### **Kent Terrace Cycleway**

**1. Traffic Modelling, Reporting and Calculations (Including SIDRA analysis) as it relates to the newly installed cycleway along Kent Terrace. To understand the predicted level of service decrease/increases for the following intersections:**

| Item | Document name/description      | Decision |
|------|--------------------------------|----------|
| 2    | Appendix 2 – Road Safety Audit | Released |

Figure 3-3: View of alternate cyclist connection utilising existing ASBs.

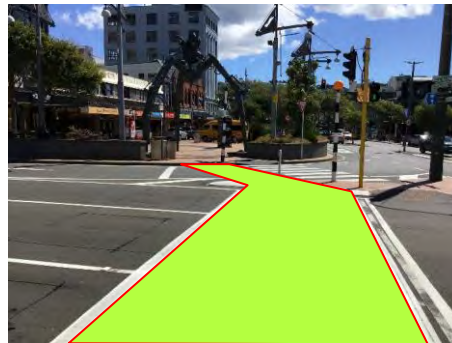
The formation of a shared path system at the connection to the cycle facility will facilitate the safe mixing of movements during peak periods.
